**Medway Planning & Economic Development Board  
Meeting**

**Rocky's Hardware – 98 Main Street**  
**Administrative Site Plan and Outdoor**  
**Display Special Permit**

REVISED DRAFT – December 8, 2021  
APPROVAL

***Site Plan and Outdoor Display Special Permit***  
***Rocky's Hardware – 98 Main Street***  
***with Waivers and Conditions***

**ROCKY'S ACE HARDWARE**  
GARDEN CENTER PLAN  
98, 108 & 114 MAIN STREET  
MEDWAY, MA.  
FOR  
**MEDWAY REALTY, LLC**  
DATE: JULY 12, 2021

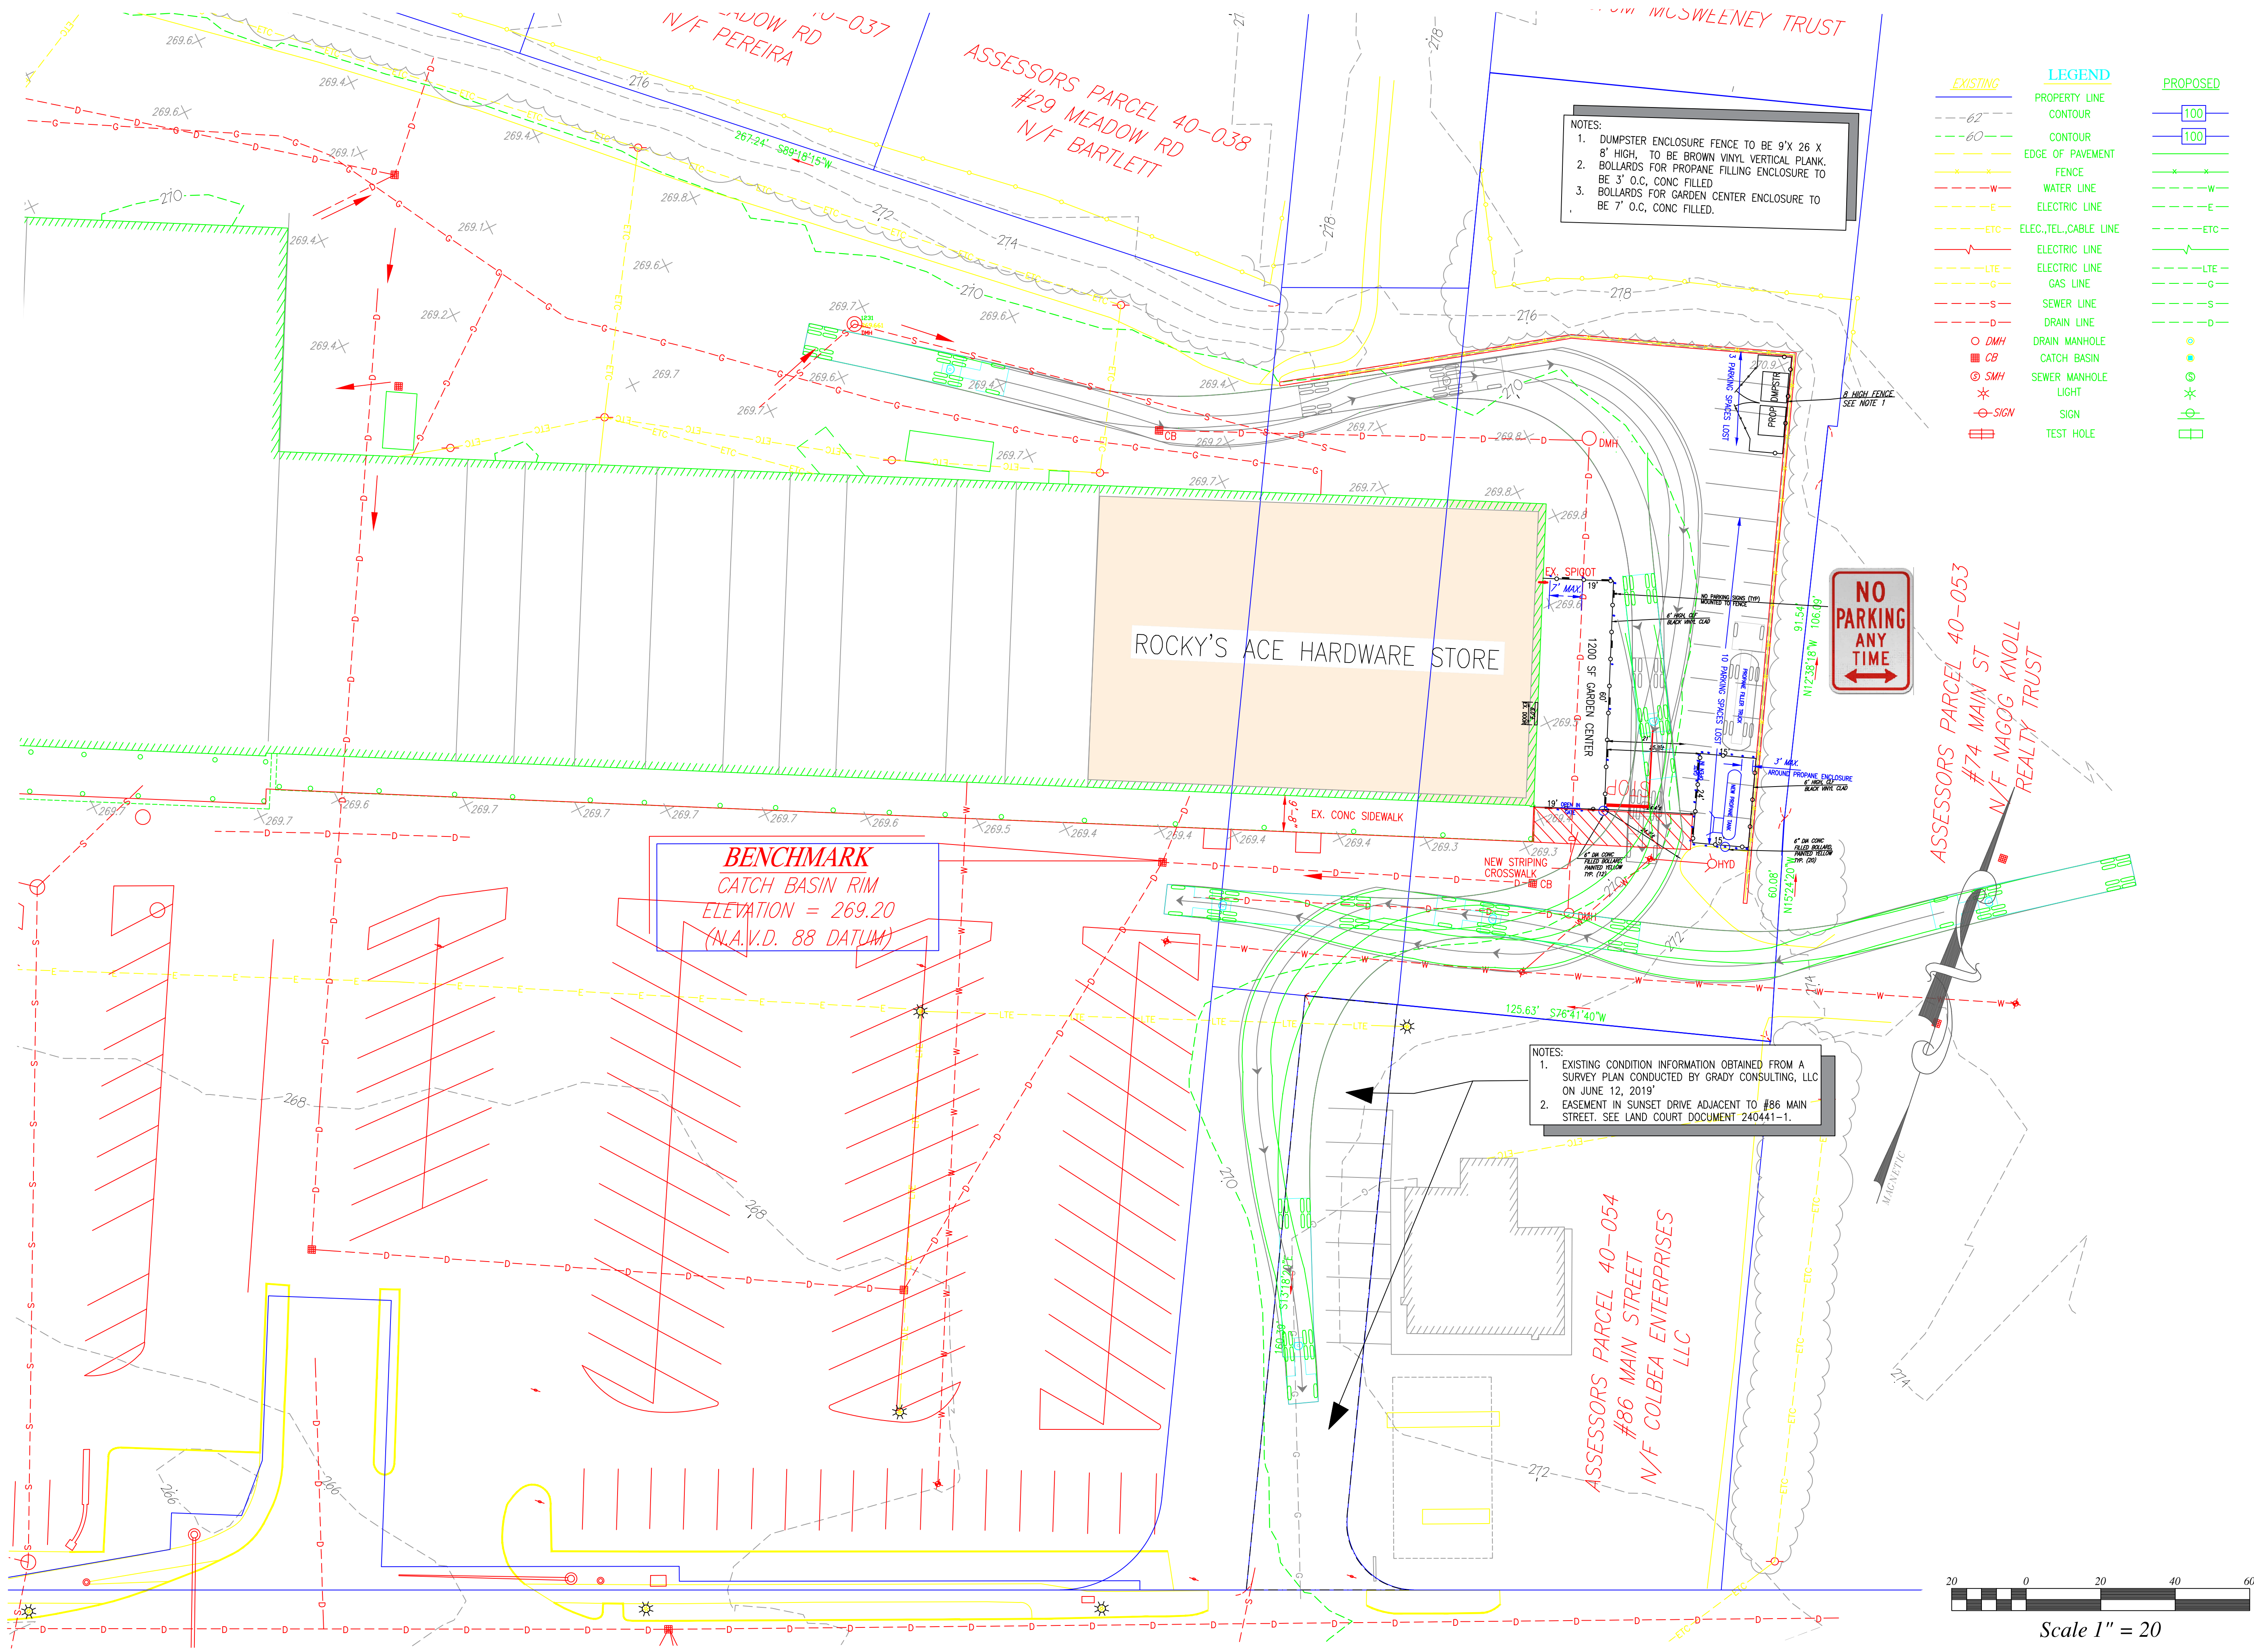
Second, the Draft Decision refers to and requires changes to the site plan separately submitted to the Board by Medway Realty under reservation of right as part of a major site plan review process, which the Draft Decision identifies as "Medway Place Site Plan and Landscape Plan and / Prepared by Howard Stein Hudson, Boston, MA / Dated April 22, 2021, last revised September 30, 2021" (the "Parking Site Plan"), and states that this plan will be "further revised as specified herein".

With respect to the second issue above, please make it clear in the special permit and site plan review decision that the only approved site plan is the plan prepared by Sugrue Associates. Although Rocky's introduced a long-since-outdated version of the Parking Site Plan early on the special permit and site plan review proceedings, that plan was supplanted by the Sugrue Associates plan, no longer represents Medway Realty's proposal in its own site plan review proceedings, and Medway Realty has not authorized Rocky's to submit the Parking Site Plan for review or approval as part of Rocky's applications for a special permit and site plan review. As is clear from the identification of the property as 98 Main Street, only part of the property shown on the Parking Site Plan is at issue here: the part of the property that Rocky's is seeking approval to improve as shown on the Sugrue Associates plan.

- B. **Plan Revisions** – Prior to plan endorsement, the following plan revisions shall be made to *Rocky's Ace Hardware Garden Center Plan* dated 7-12-21, last revised 9-9-21 prepared by Sugrue Associates of Smithfield, RI to be approved by the Board.

1. The Revised Plan sheets shall comply with Section 206-4 E of the *Site Plan Rules and Regulations* including the addition of a standard cover sheet to include approved waivers, index, signature box, etc.

2. The Revised Plan shall be formatted suitably for recording at the Norfolk County Registry of Deeds
  3. The Revised Plan shall specify the revised one-way traffic pattern west to east behind the building pursuant to Specific Condition D.3.

4. The Revised Plan shall include added details and notes regarding the text and locations for signage to prohibit the use of the paved area to the east of Rocky's pursuant to Specific Conditions D.3 and D.5.
